Re: 40 Island Way -The Standard - Comments Dated 5/20/2024

Traf Tech Engineering, Inc. has addressed the traffic-related comments prepared by The Corradino Group (comment dated May 20, 2024). The responses to the traffic-related comments are provided below:

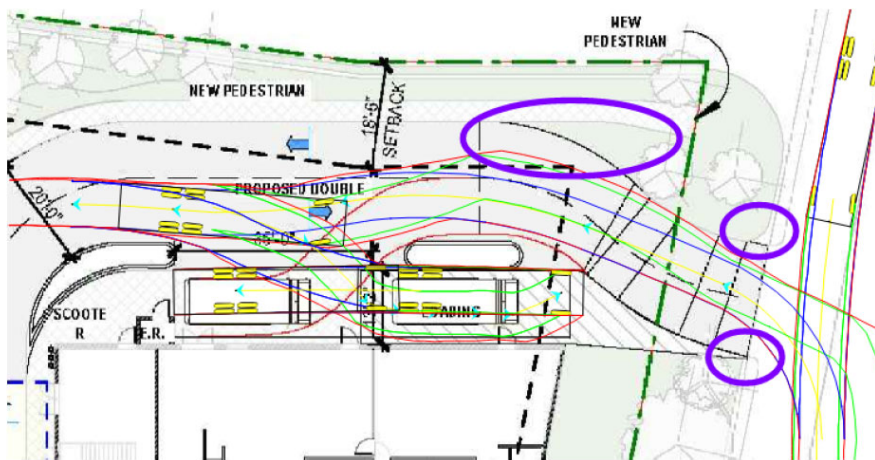
Comment 8: Multiple maneuverability exhibits show the design vehicle accessing the site from Island Avenue's opposite direction of travel and/or backing into the site while zigzagging along the proposed horizontal curves of the drive aisle. Please consider modifying the proposed access driveway's radii with a larger one, as well as straightening the access to the site. This will not only assist larger vehicles by easing access to the site but may also help with better visibility while backing into the site. (See snippet below)

Response 8: The updated traffic study includes updated AutoTURN superimposed on the latest site plan. As in most cases, trucks tend to use all available pavement widths to park/unpark their large vehicles during the loading/unloading operation.
